Access Compliance Report

Public Rights-of-Way

Intersection ID: 44072	Main Street: SEDGEMOOR_LN	Cross Street: OVERSTONE_CT	Location: NW
ADA ID: E53D98C0CF81	Ramp Type: PerpDiag	Initial Pass/Fail: Fail	Overall Compliance: No
		Severity Score: 35

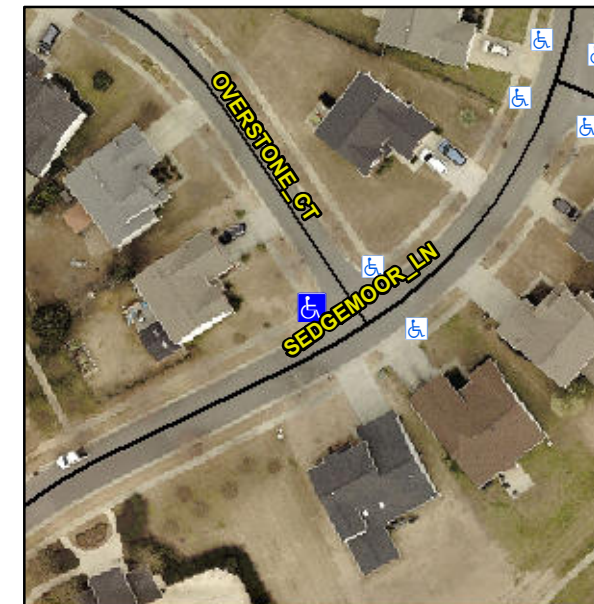
Compliance	Description	Data	Compliance	Description	Data
N/A	Ramp Length (in)	70.0	Yes	Ramp Slope (%)	5.6
No	Ramp Width (in)	25.0	Yes	Ramp XSlope (%)	0.5
N/A	Flare Type LT	N/A	N/A	Flare Type RT	N/A
N/A	Flare Slope LT (%)	N/A	N/A	Flare Slope RT (%)	N/A
N/A	Flare Traversable LT?	N/A	N/A	Flare Traversable RT?	N/A
N/A	Landing Length (in)	N/A	N/A	DWS Provided?	N/A
N/A	Landing Width (in)	N/A	N/A	DWS Contrast?	N/A
N/A	Landing Slope (%)	N/A	N/A	DWS Length (in)	N/A
N/A	Landing X Slope (%)	N/A	N/A	DWS Full Width?	N/A
N/A	Landing Curb? (Y/N)	N/A	N/A	DWS Offset (in)	N/A
N/A	Shared Landing?	N/A			
N/A	Gutter Ponding?	N/A	N/A	Gutter Slope (%)	N/A
N/A	Gutter Lip Ht (in)	N/A	N/A	Gutter X Slope (%)	N/A
N/A	Painted X Walk1?	No	N/A	Painted X Walk2?	No
	X Walk 1 Direction	To SE		X Walk 2 Direction	To NE
N/A	X Walk 1 Width (in)	N/A	N/A	X Walk 2 Width (in)	N/A
	X Walk 1 Slope (%)	0.7		X Walk 2 Slope (%)	0.6
	X Walk 1 X Slope (%)	0.0		X Walk 2 X Slope (%)	3.0

Remove & Replace Curb Ramp With Two New Directional Ramps or Equivalent.

R304.5.1
